**APPENDIX 9: APPEAL RESPONSE (TRANSPORTATION) LETTER PREPARED BY CS CONSULTING**

**Doc. Ref.** 1NWQ-CSC-ZZ-XX-LT-C-0001-P0

**RE: Appeal Response (Transportation) in relation to DCC Planning Reference 3274/24  
at 1 North Wall Quay, Dublin 1, DO1 T8Y1**

## Environmental Impact Assessment Report – Response to DCC Refusal

Figure 1 – Autotracking of Service Vehicle

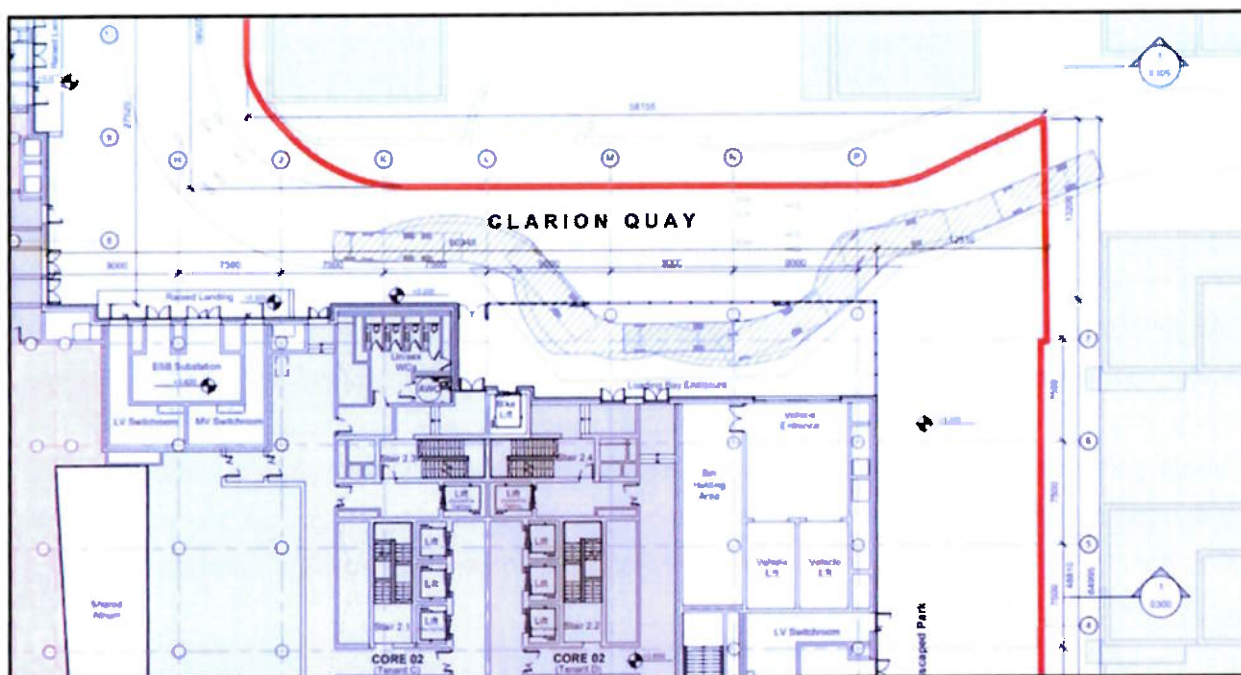
"This division have concerns with the reliance on the servicing area on Clarion Quay to meet the servicing needs for a development of this scale. The applicant is requested to re-examine the proposed servicing arrangements with a view to ensuring that servicing arrangements can be carried out without impact on pedestrians and vulnerable road users alike. Whilst this division has no objection to surface level area being used on Clarion Quay for servicing, it is preferred that servicing is within the site itself, with priority given to pedestrians in this regard."

The proposed development's vehicular servicing arrangements maybe modified by condition through the provision of a loading bay enclosure off Clarion Quay, within the building curtilage. This would ensure that servicing vehicles have a clearly defined, secure area within which to stop, and prevents obstruction of the Clarion Quay carriageway and footpath. See Henry J. Lyons architectural drawing no. 1NWQ-HJL-AX-00-DR-A-0100 for details. An extract of drawing 1NWQ-HJL-AX-00-DR-A-0100 is included in Figure 1 below outlining the autotracking of a servicing vehicle entering the proposed designated service area.

The 2 number parking spaces shown on Clarion Quay in the initial planning submission maybe modified by condition to another external loading bay/set-down area for refuse collection and taxi

drop off facilities, etc. We note, the refuse staging area shall be adjacent to this potential loading bay providing off road temporary parking for refuse vehicles on Clarion Quay preventing delays to other road users on Clarion Quay.

**Figure 3.1** South elevation for Reduced Massing Option, including redline illustrating reduced massing (Source: HJL Architects, Drawing Ref. 1NWQ-HJL-AX-ZZ-DR-A-0202)

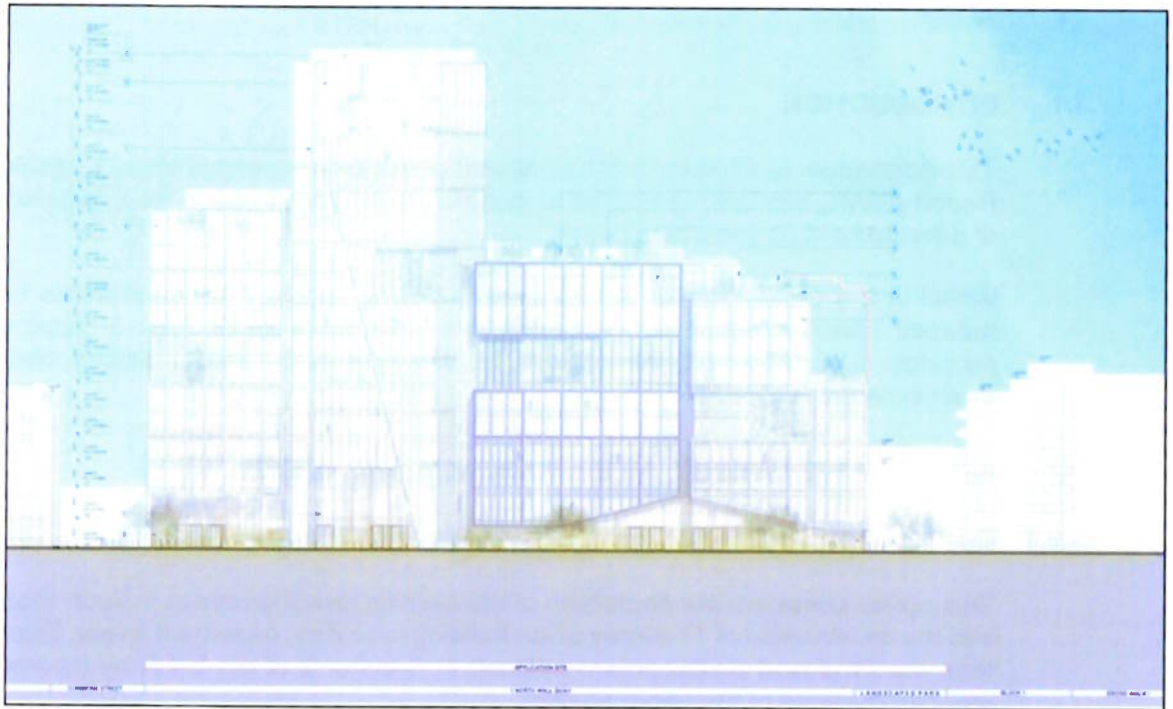
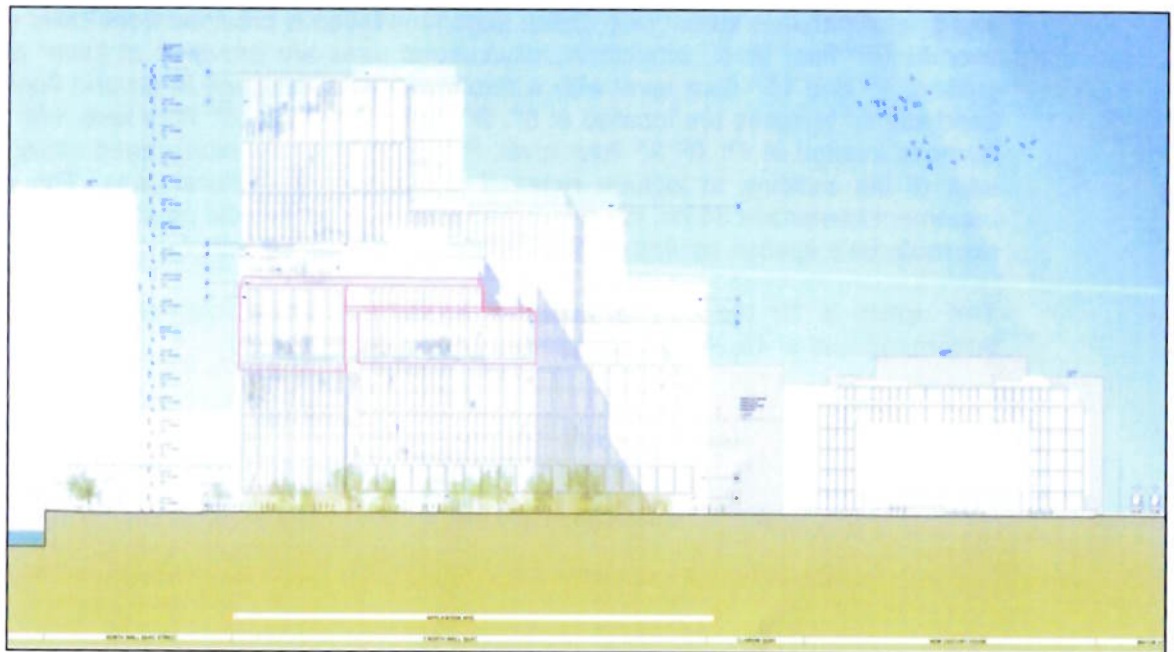
*"The Planning Authority notes however, that no alternative has been provided where a reduced scale of building was considered."*

This option provides for the demolition of the existing building and construction of a new building ranging in height from 9 no. to 17 no. storeys over lower ground floor and double basement comprising of office accommodation, arts/community/cultural uses and a retail/café/restaurant unit. Office accommodation is provided from lower ground floor to 15<sup>th</sup> floor level, arts/community/cultural uses are provided at lower ground, ground, 1<sup>st</sup> and 16<sup>th</sup> floor level with a retail/café/restaurant unit at ground floor level. Landscaped terraces are located at 8<sup>th</sup>, 9<sup>th</sup>, 10<sup>th</sup>, 11<sup>th</sup>, 15<sup>th</sup>, 16<sup>th</sup> floor level with winter terraces located at 4<sup>th</sup>, 6<sup>th</sup> 9<sup>th</sup> floor level. Provision of a new landscaped street to the east of the building to include external arts/community/cultural uses. The double basement comprises 30 no. car parking spaces, 923 no. bicycle parking spaces and 6 no. motorbike spaces as well as shower/changing facilities and plantroom.

This option is for the establishment of 85,907 m<sup>2</sup> Gross Internal Area (including basement) and of 45,267 m<sup>2</sup> net internal area of office space.
